AN/AMT-22 METEOROLOGICAL  
DROPSonde DEVELOPMENT

FINAL TECHNICAL REPORT

CONTRACT NO. N62269-76-C-034

JMR Systems Corporation  
5 Tinkham Avenue  
Derry, NH 03038

DIAGRAM 1

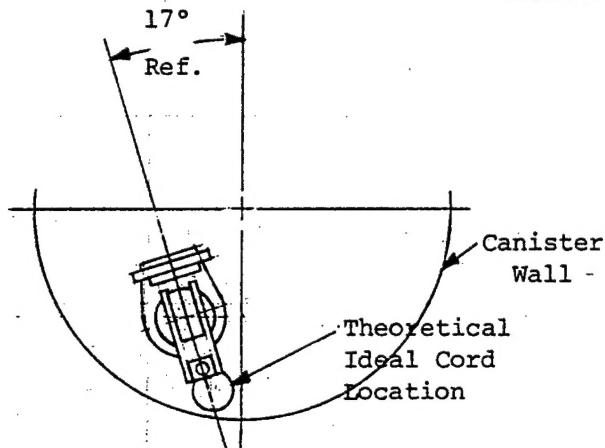
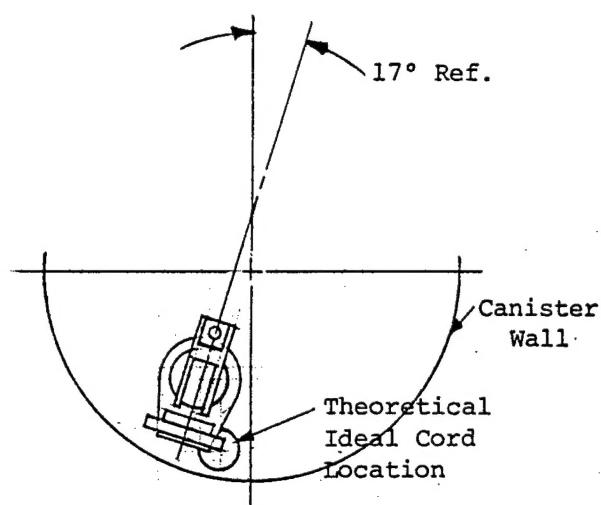
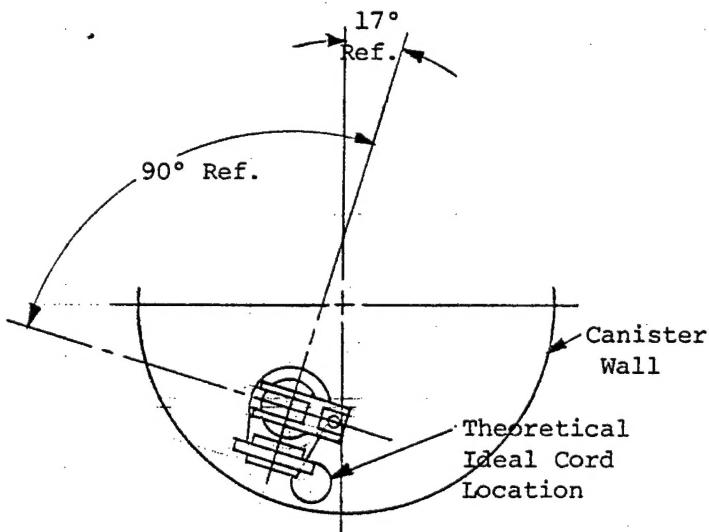
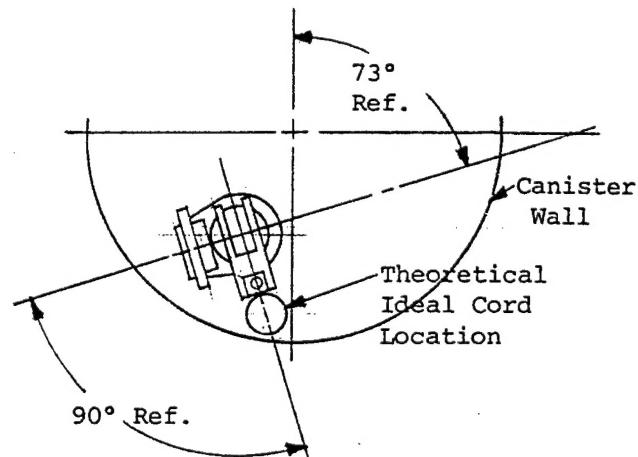
(1) The profile of the lanyard pin release cam had originally ridden against the spring loaded moisture cover of the phone jack. It was found that the spring prevented smooth removal of the lanyard pin, thus forcing the cam, at times, to have an uneven contact with the cover and the lanyard pin to be "pushed" by the cover when the former is partially removed. (see Diagram 1). Also, to prevent the possibility of any excess lanyard cord material (beyond where the knot secured the cord to the release cam) either dislodging the cam from its position, or otherwise fouling the release action; because of the insertion of the main chute assembly, the knot may be eliminated and the cord heat sealed (mushrooming the end) at assembly to attach the cord to the cam. Since no parts had to be changed to implement this revision, it was incorporated into the 100 units.

(2) The moisture cover does not completely close because the thickness of the antenna platform allows too much of the threaded portion of the jack to protrude through into the interior of the antenna housing.

Disadvantages: (1) Uneven cocking of lanyard pin during removal due to action of spring loaded jack cover on shaft connecting pin to cam  
 (2) Possible pinch of bag/chute against canister wall.

Disadvantages: (1) Poor cord location.  
 (2) Uneven cocking of lanyard pin during removal due to action of spring loaded jack cover on shaft connecting pin to cam.

The rubber seal of the cover then contacts the threaded portion of the jack, rather than the nut of the moisture cover. Trimming .094 inch from the length of the threaded portion of the jack would correct this problem, but the jack would no longer be an off-the-shelf part. The alternative is to mount the jack with an .094 inch thick spacer between the jack shoulder and the antenna platform. However, the lanyard pin, 0.469 dimension, would have to be lengthened to 0.594 inches (.125 inch longer) to compensate for the addition of this spacer. (Note that the lanyard pin had been procured before it was found that the previously used jack was no longer available. The replacement jack was slightly different than the sample submitted to JMR for evaluation. That is why this was not resolved).

Advantages: (1) Good cord location

(2) Eliminates possible pinch of bag chute against canister wall.

(3) Prevents uneven cocking of lanyard pin during removal due to action of spring loaded jack cover on shaft connecting pin to cam.

(1) Best cord location

(2) Eliminates possible pinch of bag chute against canister wall.

(3) Prevents uneven cocking of lanyard pin during removal due to action of spring loaded jack cover on shaft connecting pin to cam.
